# METROPOLITAN GOVERNMENT OF NASHVILLE AND DAVIDSON COUNTY

## STAFF RECOMMENDATION 1210 Gartland Avenue January 15, 2013

**Application:** New construction-infill; Setback determination  
**District:** Lockeland Springs-East End Neighborhood Conservation Zoning Overlay  
**Council District:** 06  
**Map and Parcel Number:** 08313017200  
**Applicant:** DeRon Jenkins, DY Construction  
**Project Lead:** Paul Hoffman, paul.hoffman@nashville.gov

Figure 4. Historically outbuildings were located close to the rear alley in this neighborhood.

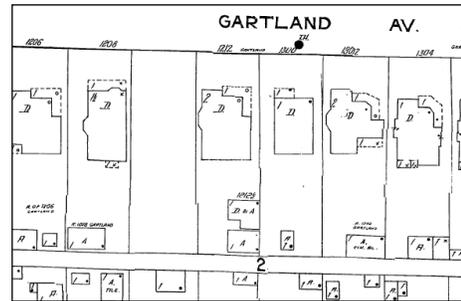
Outbuildings: The project includes a one-story, two-bay garage at the rear of the lot with a concrete parking pad on each side, creating a total of 4 parking spaces. The location is appropriate since historically outbuildings were located at the rear of the lot. The proposed outbuilding will be ten feet (10') from each side property line and six feet (6') from the rear property line. It will have doors

opening into the alley, and requires a rear setback determination from ten feet (10') to six feet (6'). Historically, outbuildings on the rear property line were a normal occurrence. Staff has determined that the six foot (6') setback is appropriate since the location is appropriate and the outbuilding is only one-story.

**Front Elevation**  
 SCALE 1/8" = 1'-0"

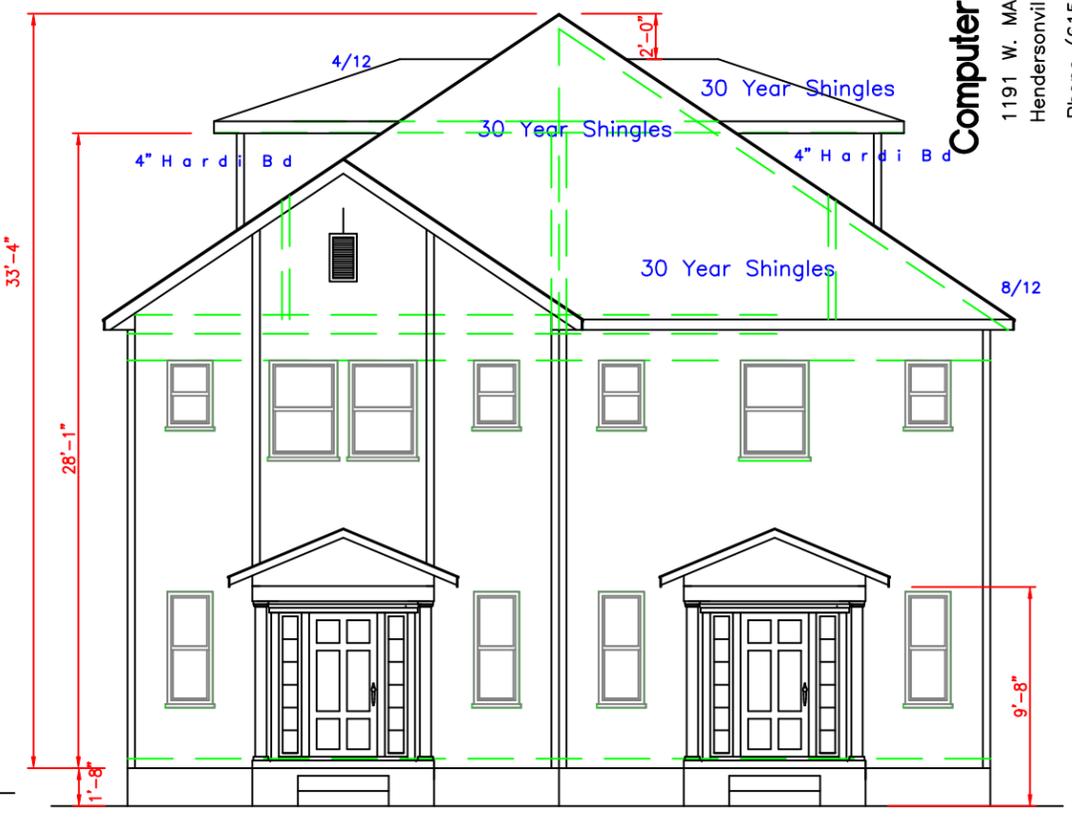
Foundation height is one foot eight inches (1' 8") from grade. The applicant has stated that the foundation shown on the current drawings may not be correct. Staff recommends revised drawings be submitted, prior to the permit being issued, showing actual foundation height and the scale of the site plan.

48 Feet  
1210 Gartland

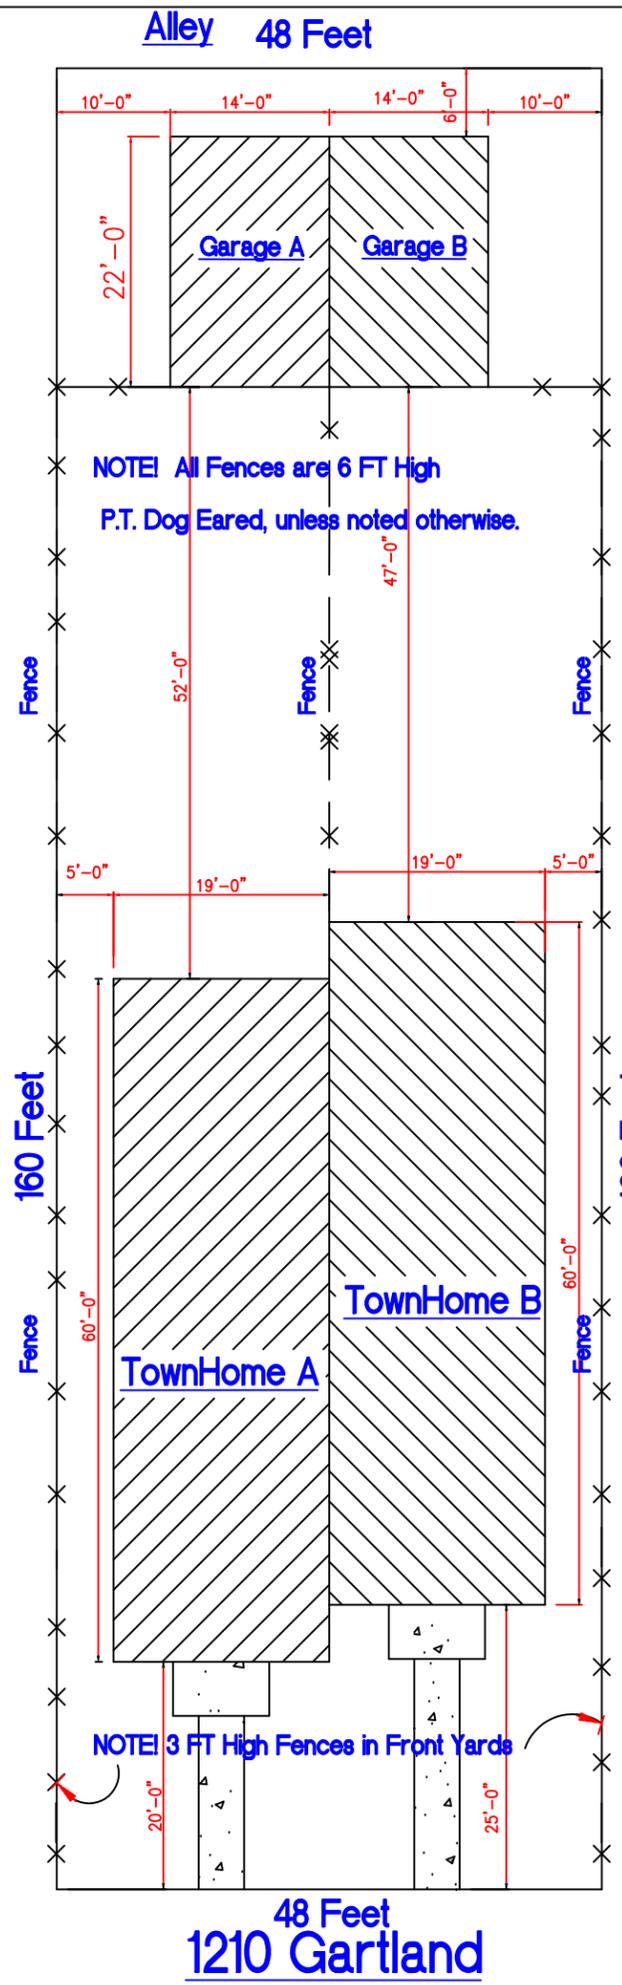
The lot is forty-eight feet (48') by one hundred sixty feet (160'). The building will be centered side-to-side on the lot with five feet (5') of setback on each side. The two units of the house are set back from the front property line twenty feet (20') and twenty-five feet (25'). The current site plan does not show the footprints of abutting properties. In the absence of this detail, staff asks that the front wall of the projecting gable maintain the established setback along Gartland Avenue. Meeting these conditions, staff finds the project meets Section II.B.3 for setback and rhythm of spacing.

Appurtenances & Utilities: Fencing for the project is noted as being three feet (3') and (6') tall but the plans do not indicated at what point the height changes. Staff recommends that the six foot (6') fence wrap from the midpoint of the homes, back around the rear yard, and that only the three (3') fence be located forward of the mid-

point of the building. The location of the HVAC and other utilities was not noted on plans. Staff requests that the HVAC be located on the rear façade, or on a side façade beyond the midpoint of the house. The project meets Section II.B.9.

Garage Alley Elevation  
SCALE 1/4" = 1'-0"

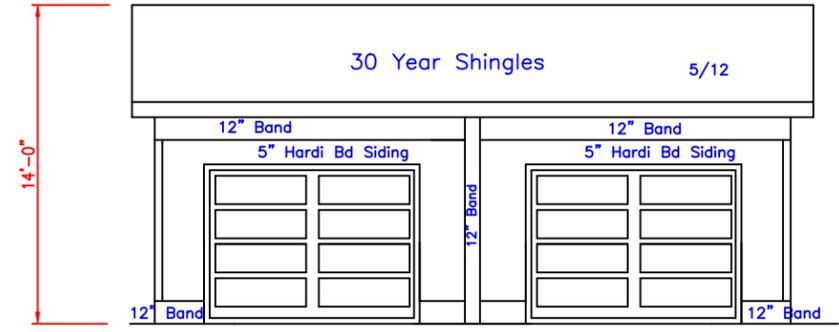
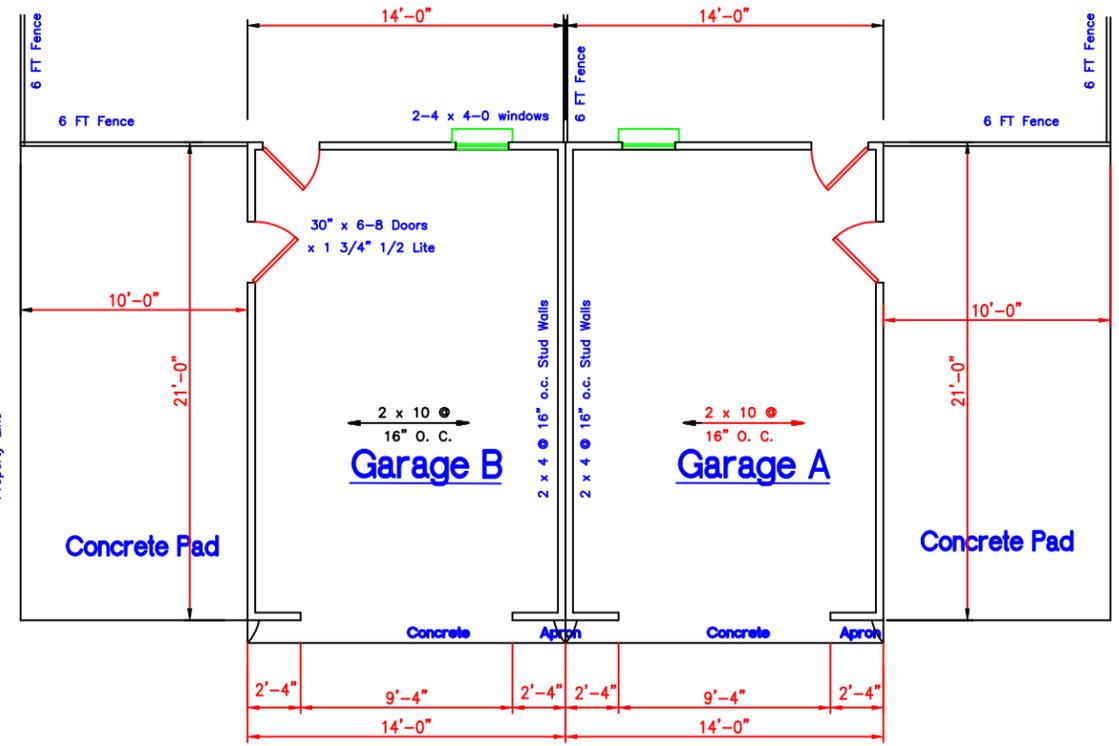
The garage measures twenty-eight feet (28') by twenty-two feet (22') with a footprint of six hundred and sixteen feet (616 sq.ft). Its scale and massing are subordinate to the principle structure and similar to historic outbuildings. Its roof is a side-facing gable with asphalt shingles. Not all of the materials for the garage were indicated.

With a new setback determination and clarification of materials, the outbuilding is compatible in terms of height, scale, roof shape, materials and details and meets section II.B.8.
